# Township of Guelph/Eramosa

## Halton Region Review Document Book Index

**RE: Notice of Objection**  
**Application under the *Aggregate Resource Act* by James Dick Construction Limited for a Class 'A' Category 2 Licence – Aggregate Operation for a 24.8 hectares Quarry on the lands legally described as West Half Lot 1, Concession 6, former geographic area of the Township of Eramosa – Township of Guelph/Eramosa, County of Wellington**

**RE: Region of Halton Request for Additional Information  
"Hidden Quarry" – James Dick Construction Ltd.  
Proposed Class 'A' Category 2 License – Aggregate Operation  
Township of Guelph/Eramosa Zoning By-law Amendment Application ZBA 09/12  
West Half Lot 1, Concession 6, former geographic area of the Township of Eramosa**

**Figure 4:**  
**Downgradient Private Wells**

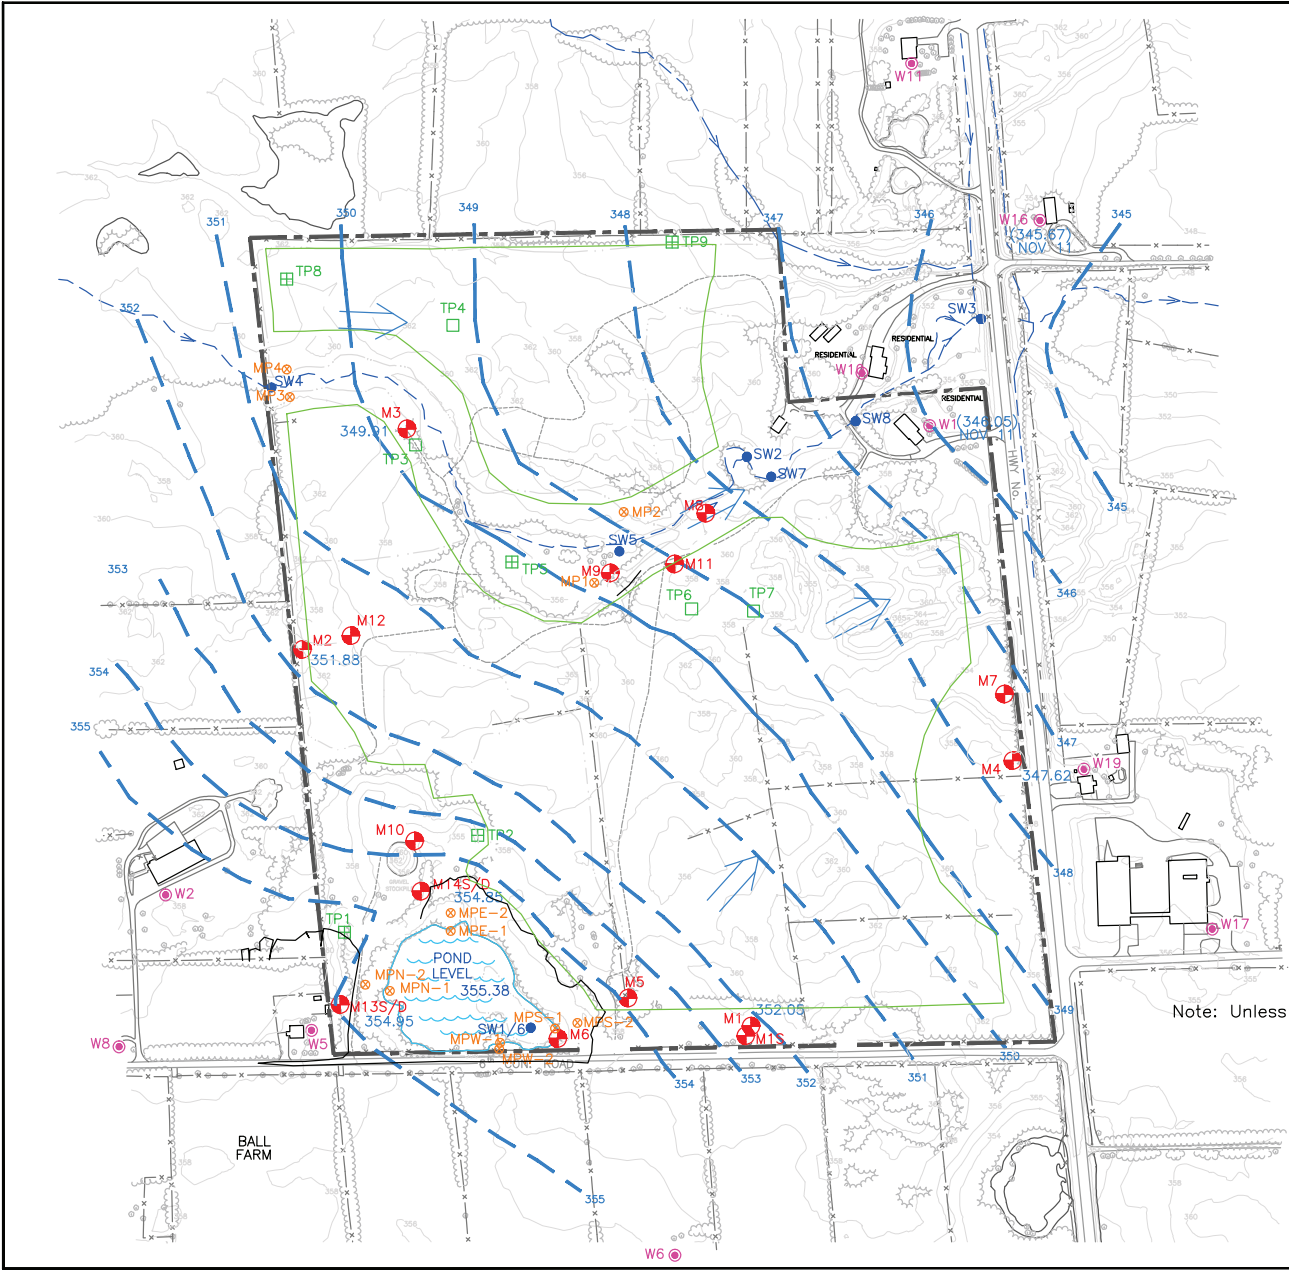
19	Region Halton	28-Jul-14	<ul style="list-style-type: none"> <li>Page 3 of 5: (i) What are the anticipated "silt pond" depth/fill elevation in relation to groundwater levels to the south? The pond is proposed almost directly to the north of a sensitive receptor (private well W 19 defined as R16 on the site plan) in Halton Region. Is M4 installed to monitor potential impact from this pond? In reference to a "blasting line" on the south side of the west extraction area, what monitoring is proposed to ensure that private wells and other structures to the south (i.e. in Halton Region) are not affected by blasting activities?</li> </ul>	<p>The silt pond will be located above the bedrock and will be above water table (please note that the silt pond is generally located in the blasting setback where bedrock quarrying will not be taking place- Site Plan Page 3 of 5). Water in the washing system is closed loop and all water is recycled. Private well W19 is located to the south of the silt pond. Examination of bedrock ground water pre-extraction contours in this area (Figure 3.17 Bedrock Groundwater Contours of the September 2012 Harden Report ) demonstrate that groundwater flow is almost due east, not towards W19. The overburden is dry in this area. Only during the later stages of extraction, with the establishment of the lake, does this well begin to draw water directly from the quarry area (please see the figure "Downgradient Private Wells" attached). Monitor M4 is located between the quarry and well W19 and would function to ensure water quality and quantity in off site wells located in a southerly direction. Washing aggregates is a clean activity and no chemicals are added to the process. Water is used to physically sort virgin, native materials of different grain sizes. Water naturally infiltrating the site today comes into intimate contact with these particles prior to recharging the bedrock aquifer. Water quality and quantity will be assessed in private wells prior to blasting operations. A well complaint protocol has been established should a resident feel that their well has been affected by blasting or other quarry activities. Furthermore, on-site monitoring will assess water levels and groundwater quality before leaving the site on a regular basis. All blasting events will be monitored to ensure compliance with MOE Blasting Guidelines. All blasts shall be monitored for both ground vibration and overpressure at the closest privately owned sensitive receptors adjacent the site, or closer, with a minimum of two (2) digital seismographs – one installed in front of the blast and one installed behind the blast. Monitoring shall be performed by an independent third party engineering firm with specialization in blasting and monitoring.</p>	Attach Figure 4 "Downgradient Private Wells" and Figure 3.17 "Bedrock Groundwater Contours"	JDCL
